Dear Mark,  
RE: 10 SthEnd Osmotherley Note ref Drwgs 4A and response on Dble Glzng email

**RE: 10 SthEnd Osmotherley Note ref Drwg 4A and response to Dble Glzng comments on email 14 August2019 following submission 30 July2019**

No 10 SOUTH END CANTHURLEY Aug 2019  
PROPOSED WORKS TO FORM ONE DWELLING AND REPAIR & MAINTAIN EXISTING FABRIC.  
DRWG 4A PROPOSED REPLACEMENT OF NON HISTORIC FABRIC VERTICAL SLIDING SYSTEMS NOT REQUIRING REPAIRMENT WITH SIMILAR PROVISIONS BUT MORE FLEXIBLE

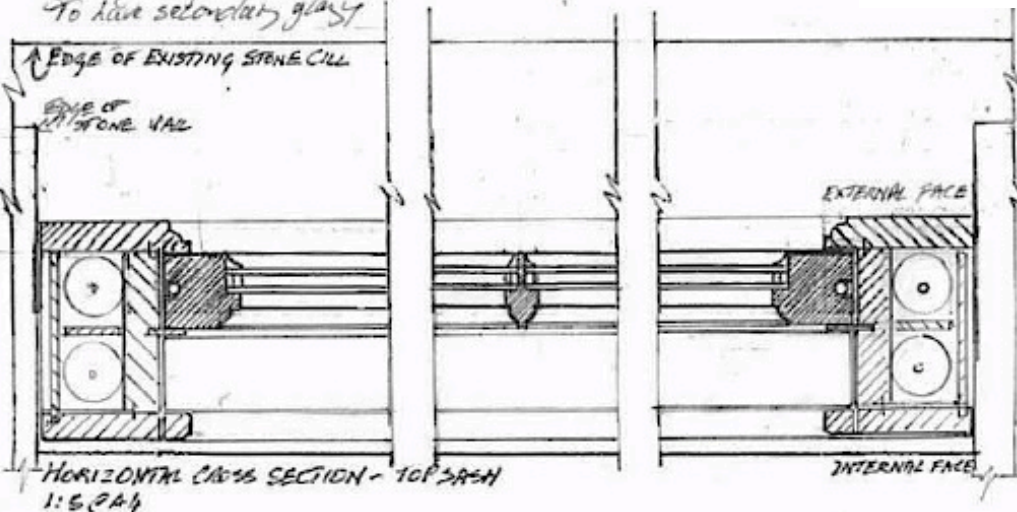
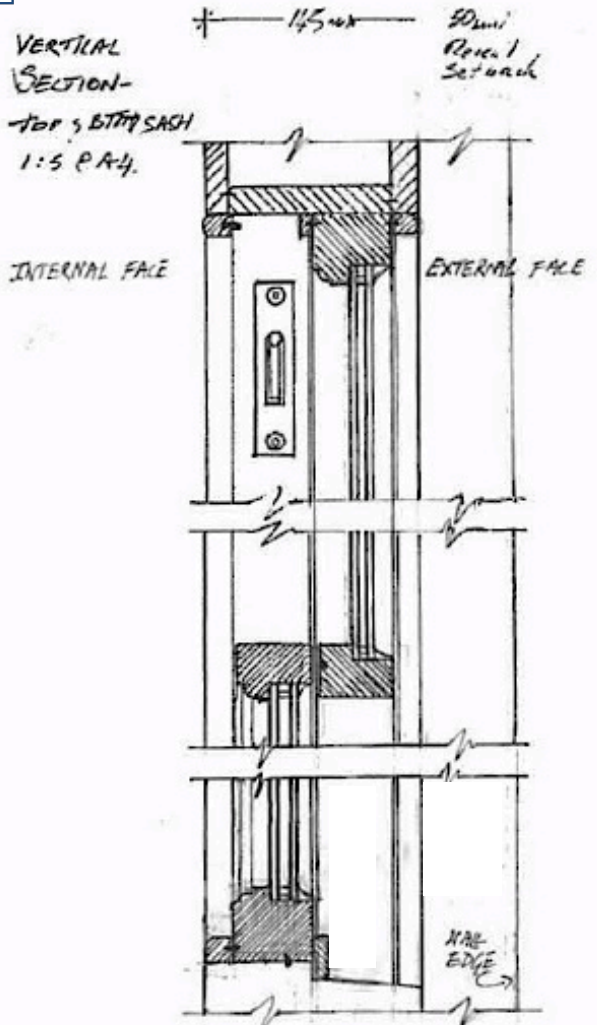
In respect of NYM reasons for refusal for the envisaged bespoke windows, I attach by return, a revised design – Drawing 4A, to replicate the proportions of the existing elevation of the 80's replacement rear vertical sash windows that are perceived by NYM as being 'correctly proportioned, detailed, and retaining traditional construction techniques retaining their integrity'.

the frames, the proportions, the degree of chamfering, the horns, cills and glazing bars, the profile and details of the cills with glazing acceptable to NYM. I would note the revision matches the replica '80's windows with its minimum 22mm wide glazing bar rather than the original, much earlier preferred antique glazing bar from the late Victorian period of 24mm width at the front of the building.

This addresses the detail design issues you raised and can, without significant alteration, accommodate double glazing units without damage to the fabric. It will result in a neutral impact on significance albeit with a positive impact on the future sustainability of the historic character significance through the increased resilience of the windows as a result of the use of more resilient moderated timber and hardwood, together with a reduced risk of the level of condensation.

Windows to be of moderated timber across with hard wood cills, double glazed with slim line heritage glazing set back 50mm minimum from wall face.

Minimum 50mm sash set back.  
145mm

All dimensions for fitting to be checked on site.  
All dimensions for bespoke joinery manufacture to be checked on site.  
Rev. 4A  
Timber sections modified to match existing elevation properties. Existing 90's replacement windows included, joints, glazing etc.
